**RESPONSE TO SUBMISSIONS – BUILDING R4B
SSD 6965 MOD 3**

This response to submissions letter has been prepared following the public exhibition of a section 4.55(1A) modification application for Residential Building R4B, Barangaroo (SSD 6965 MOD 3). The modification application seeks approval for internal and external design changes and administrative amendments. The modification is supported by concurrent modification applications to the adjacent Residential Building R4A (SSD 6964), and also to an Alterations and Additions development consent to Building R4B (SSD 8892219).

Figure 1 Approved driveway entrance (left) and proposed, widened entrance (right)

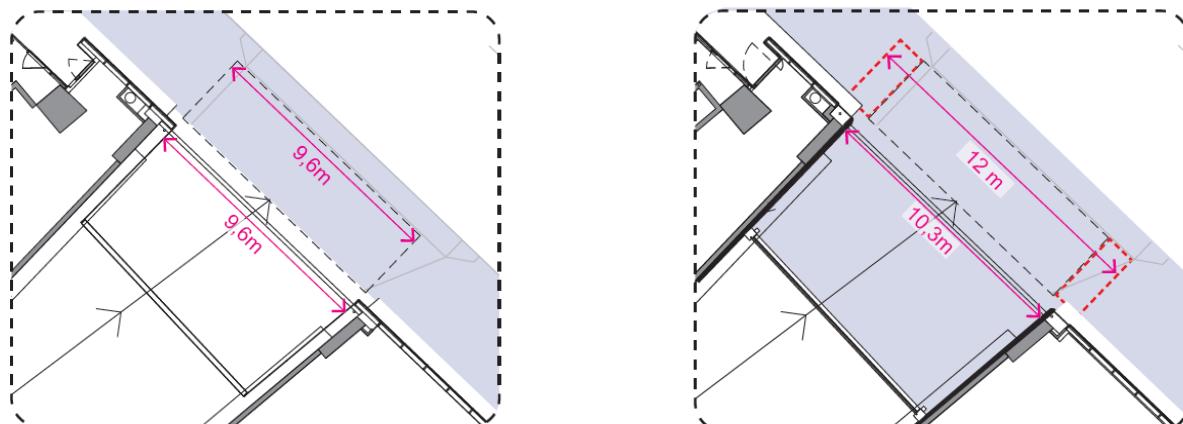
The submitted plans indicate that the ramp door is proposed to be relocated and the facade be updated, and the design report notes the carpark entry width is proposed to be increased, however, no details are provided as to the proposed new width of the opening.

The City generally recommends, as per Section 3.11.11 of the Sydney Development Control Plan 2012, that carpark openings have a maximum width of 4m to ensure pedestrian and cyclist safety and amenity is prioritised. The proposed opening of over 10m is significantly wider than this recommendation and reconsideration should be given to this aspect of the proposal.

The Building R4B basement entry driveway on Watermans Quay was originally approved to have a width of 9.6 metres. The proposed modification application seeks to widen this driveway entry by a minimal amount of 0.7 metres to a total width of 10.3 metres, within the bounds of the current building structure. This slight increase in width is proposed to reduce the risk of vehicle impacts with cladding on either side of the entrance ramp and to reduce potential conflicts with vehicles approaching in opposite directions when utilising the driveway. There is no change to the access lanes within the entry, with the amendments to enhance safety and operation.

Alongside the increase in driveway width, Council's stone paving is also proposed to be increased into the area to improve visual outcome, alongside the adjustments made to the wall cladding. The awning above the driveway is also sought to be adjusted to reflect the increased width, and ensure a holistic design outcome. The revised Design Report at **Attachment A** illustrates the widening of the awning and driveway, demonstrating that there is minimal change and the integrated design approach will ensure the driveway is not out of character with the overall design of the public realm and building interface. A diagram indicating the increased width of the driveway is shown at **Figure 1**.
